Work Order ID 89727

Item ID: D3394-3RG

Item Name: Lug

| DRAWING NO. D3394 | TITLE LUG | REV. B | DART AEROSPACE LTD ENGINEERING ORDER | | D.E.O. NO. D3394-B-1 | SHEET NO. SHEET 1 OF 1 | SCALE NTS |

SHEET 4 ZONE A,1 MODIFY SECTION A-A AS SHOWN:

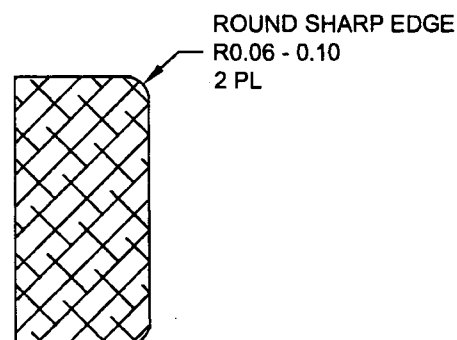
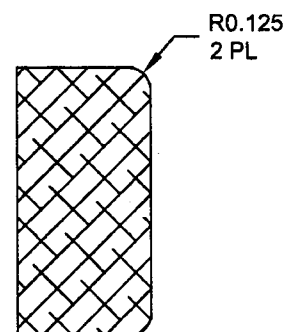
REASON: DRAFTING ERROR

D3394-1RG LUG (SHOWN)
D3394-3RG/-5RG LUGS (SIMILAR)
D3394-041RG/-043RG/-045RG LUG ASSEMBLIES (SIMILAR)

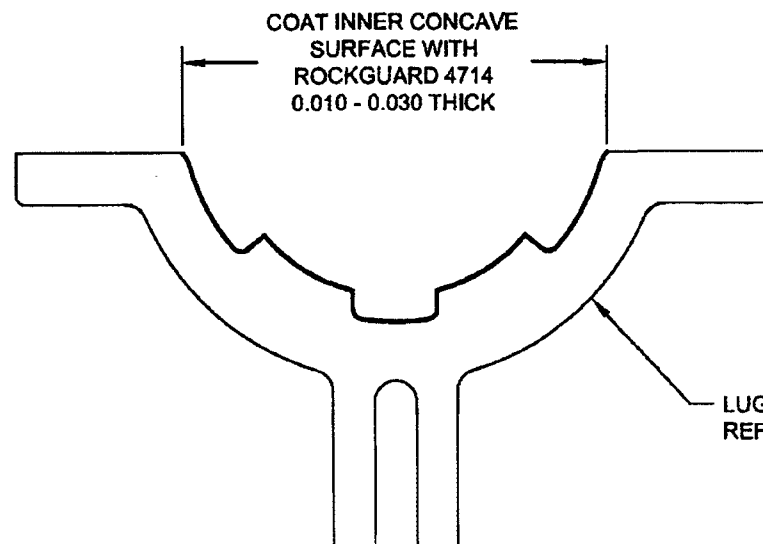
ADD D3394-xRG OPTION

D3394-xRG MOUNTING LUGS ARE INDENTICAL TO D3394-x MOUNTING LUGS, HOWEVER AFTER FINISH, COAT INNER CONCAVE SURFACE WITH "PLUS ONE ROCKGUARD 4714" AS SHOWN BELOW.
